**SYDNEY WATER
BUILDING PLAN APPROVED
SUBJECT TO REQUIREMENTS**

Dolphin No: D13/4-00559

Building/Structure Description: new residence

Building Plan No: 104-12 A19198

STRUCTURAL SLAB DETAIL PLAN

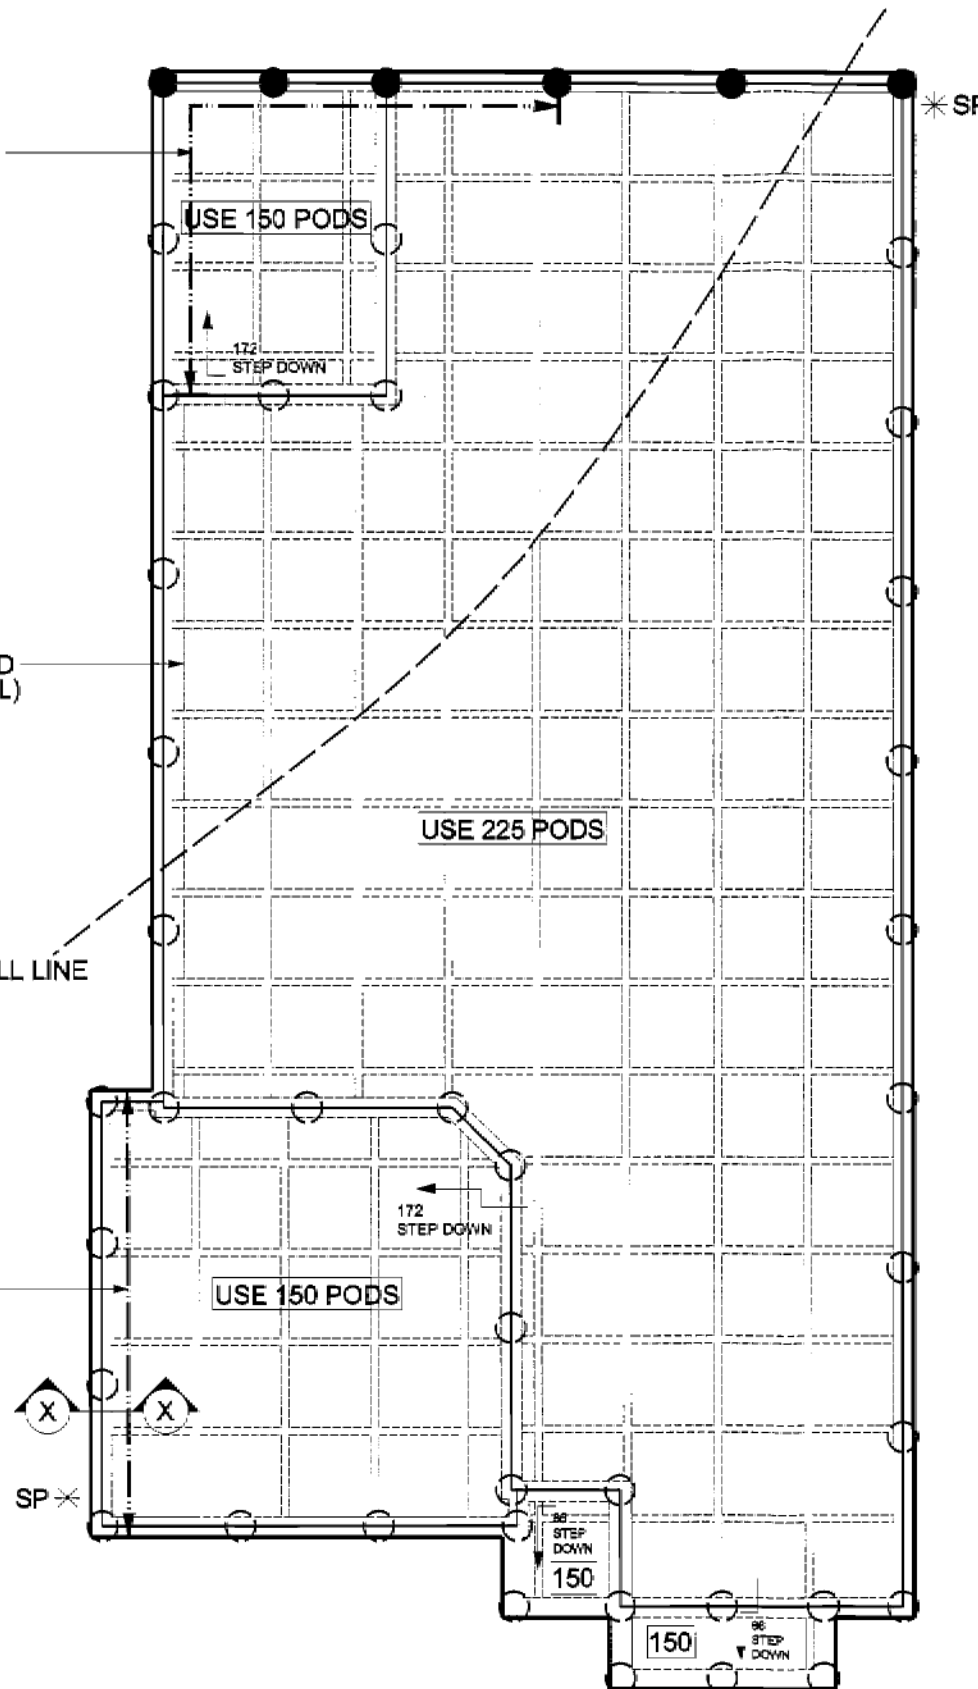
1. The foundations/piers are to be founded below 1:1 zone of influence, soil strata.
2. No part of the building/structure or its foundations to be less than a minimum 0.6 metre, horizontal distance from the centreline of the asset.
3. No part of the building/structure to be less than 1m horizontal distance from outside edge of any Sydney Water structure.
4. No piercing of building/structure to be less than 2m horizontal distance from centreline of maintenance hole to edge of piers.
5. Foundations/piers are constructed in accordance with Engineers detail plans (stated above) as submitted to Sydney Water. Please note that Qalchek are not responsible for any depths shown on these plans if during our pier inspection they are found not to extend below the zone of influence.
6. All foundations/piers are to be founded to below the zone of influence or to solid rock.

- (a) Piering Inspection by Qalchek Pty limited.
Please ensure that Qalchek are advised a minimum of 2 workings day's prior to piers being poured to enable inspection of pier holes.
